### MEMORANDUM

To: Development Review Board  
From: Mary O'Neil, AICP, Principal Planner  
Date: February 1, 2022  
RE: ZP21-816 OG, an Amendment to PUD permitted under ZP20-0717CA/MA, ZP20-0718CA, ZP20-0719CA, ZP20-0720CA; 273 Pearl St., 11, 15 and 21 Hungerford Terrace

**Request:** Amendment to previously approved Planned Unit Development (*demolition of a single family home at 15 Hungerford Terrace and a garage at 11 Hungerford Terrace; demolish south porch and move garage at 21 Hungerford Terrace; construct 12 unit residential building. Net new units = 11. Site changes, including retaining walls, stormwater infrastructure. Parking changes with 17 space parking waiver request (42% of required residential parking.)*)

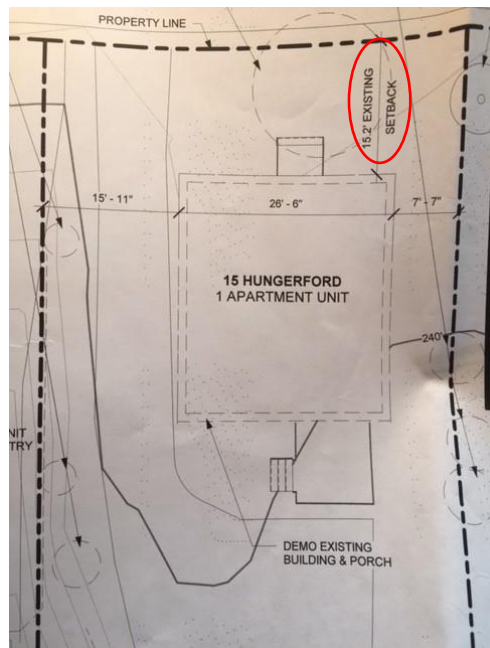
Window wells are also explicitly included as part of the allowable lot coverage bonus under **Section 4.4.5 (d) 2. A. (viii), *Exceptions for Residential Features*** (not applicable in this zoning district.) As an identified residential feature in both Article 13, *Definitions* and in this section, window wells are not commensurate with retaining walls or landscape walls, their substitution as

such inappropriate. The window wells present an encroachment (and increase in non-conformity) in this application.

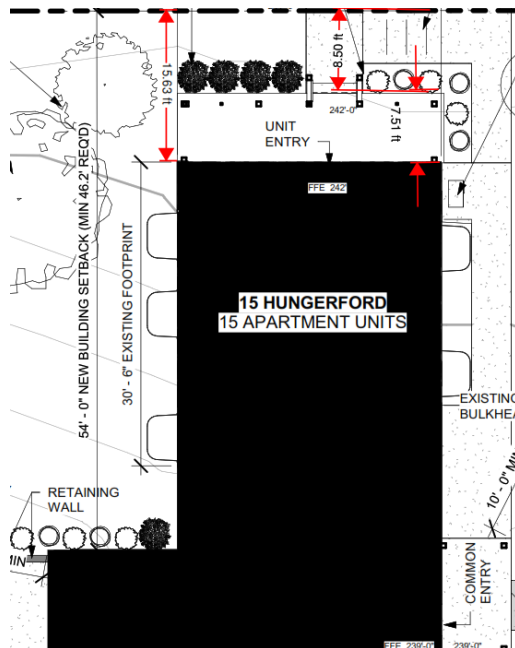
As the porch is proposed to be three stories, it does not meet the limited allowance for encroachment (*access to the first floor only*.) Unless the porch is limited to first floor entry, it too increases the level of non-conformity to setback.

Existing non-conforming front yard setback, 15 Hungerford Terrace to be recaptured; 15.2'.

Proposed front yard setback 15 Hungerford. Existing building footprint recaptures 15' setback, but window wells and multi-level front porch encroach beyond the allowance of ZAI 11-2.
